MARCH 11, 2014

PROJECT: JEFFERSON COUNTY SPORT COMPLEX

ADDENDUM NO. 1

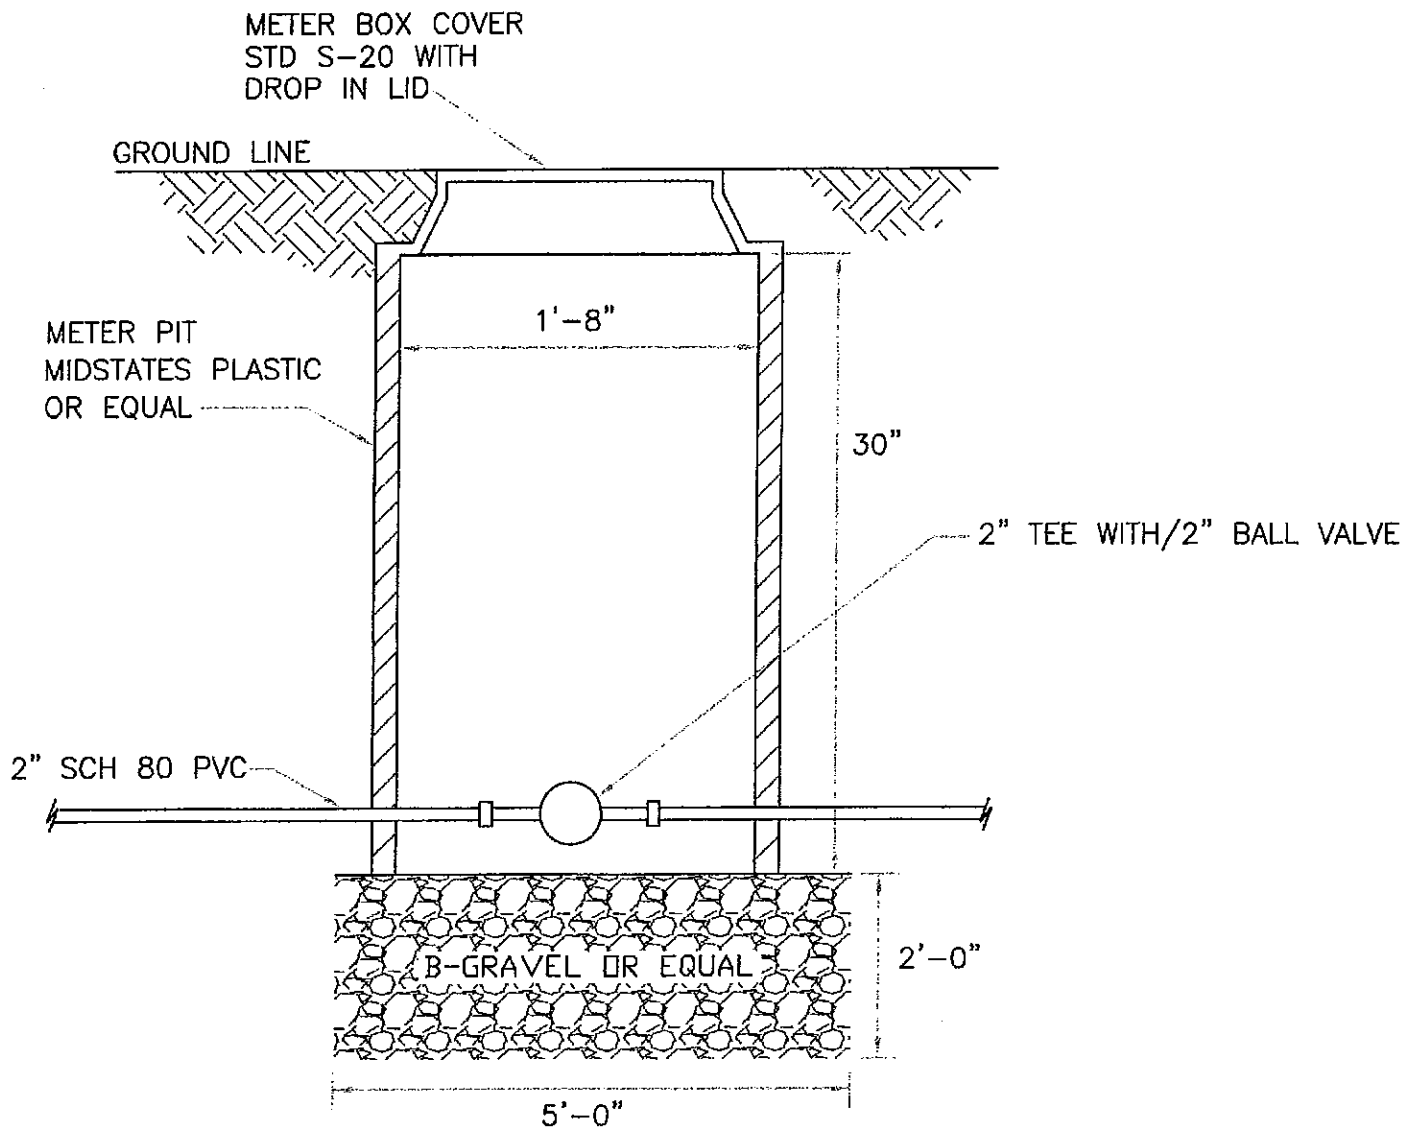
4. CHANGE 35 GALLON PRESSURE TANK TO A 20 GALLON TOTAL VOLUME, 125 PSI UNIT. PROVIDE A FLEXCON CHALLENGER PC66 MODEL OR APPROVED EQUAL.
5. MOVE PRESSURE TANK TO THE INCOMING SIDE OF THE PIPING IN BUILDING.

6. DRAWINGS SHOW 2 HOSE BIBS. CHANGE ON HOSE BIB TO A SAMPLING TAP AND MOVE TO INCOMING SIDE OF PRESSURE TANK.
7. CHANGE PRESSURE GAUGE TO 0-100 PSI DIAL.

8. REDUCE PIPING SIZE IN THE BUILDING FROM 2" TO 1-1/2" FROM PRIOR TO WATER METER TO THE DISCHARGE LINE.
9. ADD THE MANUFACTURER NAMES OF JERMANN AND MASTER METER FOR THE WATER METER.

DRAIN PIT  
NTS

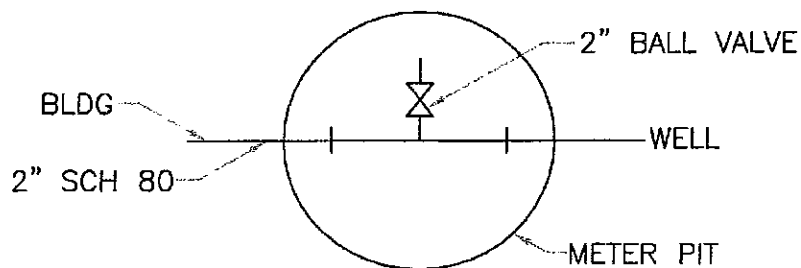
10. ADD 6" CASING TO THE BID ITEM "10" DRILL HOLE".
11. CHANGE THE AMOUNT OF 10" DRILL HOLE WITH 6" CASING TO 310 FEET FROM 350 FEET.
12. ADD DRAIN PIT ON INCOMING WATER LINE BETWEEN WELL AND BUILDING TO DRAIN WATER LINE.
